# RADIO KEYLINE MODIFICATION

**SCOPE:** This modification applies to all Sigtronics intercom (SPA-, SDB-, SCI-, Sport-) installations that will utilize both pilot and co-pilot transmit positions. See alternate solution if using pilot only transmit position.

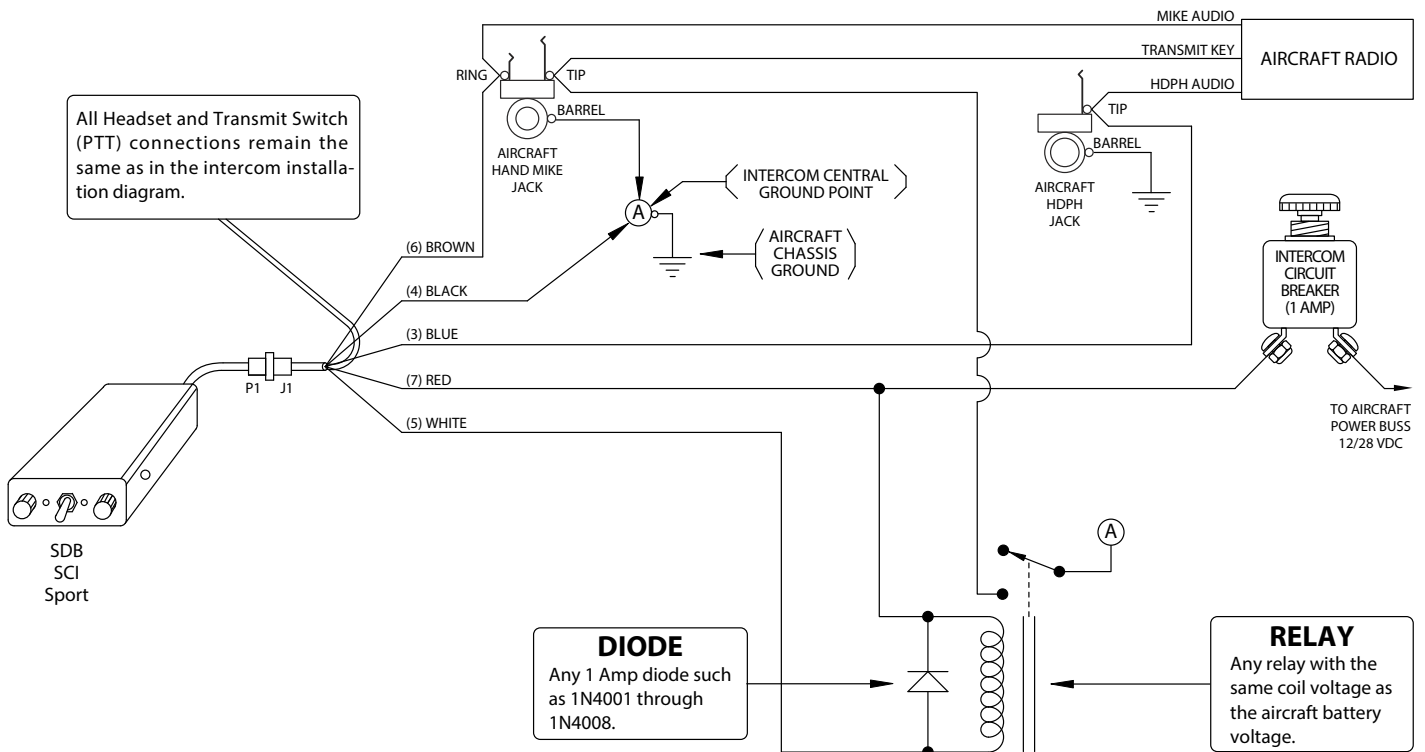
**PROBLEM:** The radio will not key up when either pilot or co-pilot PTT is pressed. This is due to the 0.7 volt diode drop within the intercom. Common installations affected usually involve KMA-20 audio panels or ICOM A220 radios.

**VERIFICATION:** Check to make sure all wiring and terminal connections are correct and unbroken. The radio will key up from the aircraft hand mike. Shorting the white wire (pin 5) to ground will key up the aircraft radio. The radio will not key from either PTT position. Shorting the white / red (pin 2) or the white / blue (pin 10) will not key the aircraft radio.

**SOLUTION:** A relay can be added to the installation that will eliminate the 0.7 volt diode drop. Follow the wiring diagram below.

**Alternate Solution:** For pilot only transmit installations. The pilot's PTT switch can be directly tied to the tip terminal of the aircraft hand mike jack. The PTT switch will still be connected to the white / red (pin 2) wire. The white (pin 5) wire will still be connected to the tip terminal of the hand mike jack.
